UNITED STATES PATENT AND TRADEMARK OFFICE

APPLICATION NO.	FILING DATE	FIRST NAMED INVENTOR	ATTORNEY DOCKET NO.	CONFIRMATION NO.
10/765,320	01/27/2004	Manfred Fuchs	24,577-26US	9408

Office Action Summary	Application No. 10/765,320	Applicant(s) FUCHS ET AL.	
	Examiner John F. Ramirez	Art Unit 3737

DETAILED ACTION

FIG. 7

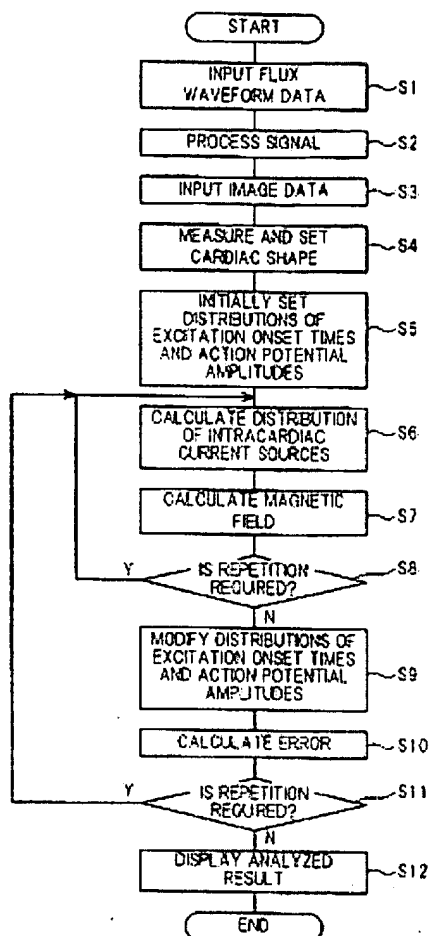
In regards to claims 1, 2, 7-11, and 12, Ohyu et al. discloses a method for acquiring a first electromagnetic physiological signal, filtering the signal for a latency range (col. 11, lines 1-8), performing a source reconstruction for the signal (Fig. 7, steps S5, S6, S7), acquiring a second electromagnetic physiological signal while the source reconstruction is being performed on the first electromagnetic signal, performing the source reconstruction includes computing a single equivalent current dipole (col. 3, lines 56-63), using a concentric sphere volume conductor model (Fig. 7, step S7), using a Boundary Element Method (BEM) volume conductor (Fig. 7, step S7), using a Finite

With respect to claim 20, Ohyu et al. shows in Figure 7 a method of testing comprising the steps of: acquiring an electromagnetic physiological signal through a test setup, determining the latency of the signal, performing a source reconstruction of the data within a predetermined latency range, and using the source reconstruction to modify the test setup.
